## Master Planning Task Force

July 19, 2011

#### **B. LAr Test Facility**

LIQUID ARGONE  
TEST FACILITY

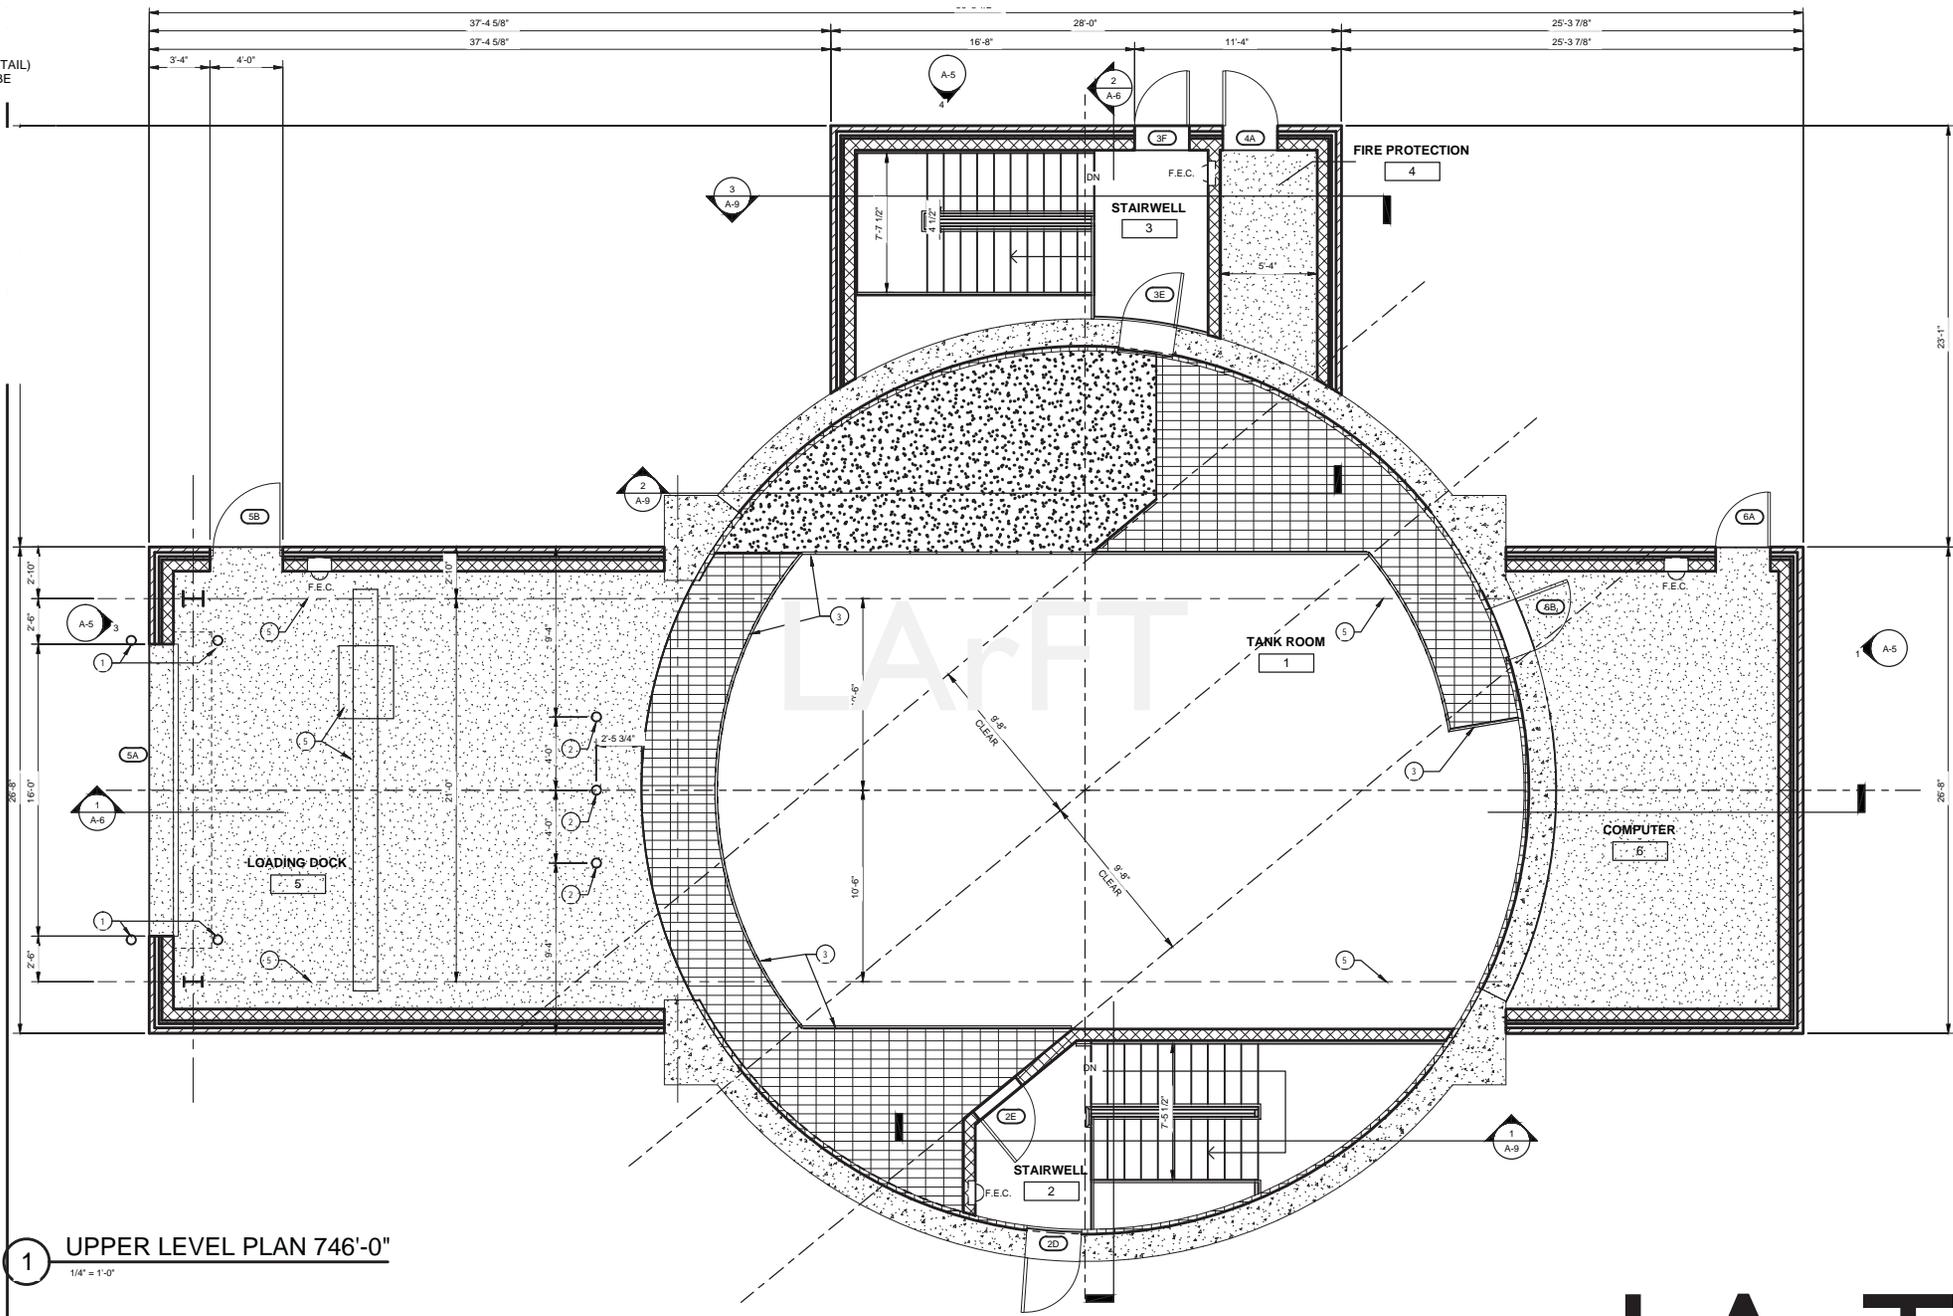
2. P. Garbincius suggested that the drawings indicate the Booster Neutrino beamline to better orientate the viewer;
3. An architectural objective of the LArTF design was to take cues from the existing MINOS Service Building, MiniBooNE Detector Enclosure and the NOvA Near Detector Surface Building. These cues included the circular massing, common materials such as brick and general arrangement. This was done to unify the site;

2 Section 2  
1/8" = 1'-0"

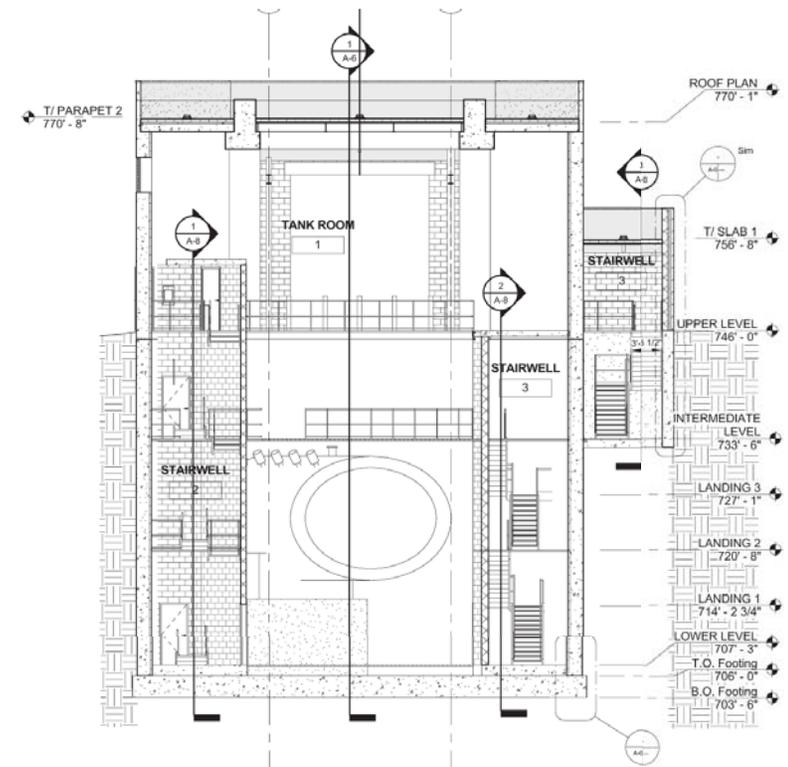
7. There was concern over the possible addition of shielding blocks after the initial construction. This shielding is thought to be needed to range out low energy cosmic rays and could be barite. R. Rameika noted that the initial running would occur without any additional shielding. The concern expressed was that these blocks detract from the strong

circular scheme. It was recommended that the circular exterior walls could be extended upward the full height during the initial construction and the shielding could be added within this space. It was thought that this would make the installation of the shielding easier in the future;

It was noted that the Master Planning Task Force felt that the design of the LArTF was acceptable and that design should continue, but that the issue of the shielding needed further study. Y. Kee-Kim noted that the design needed to be reviewed by P. Oddone.
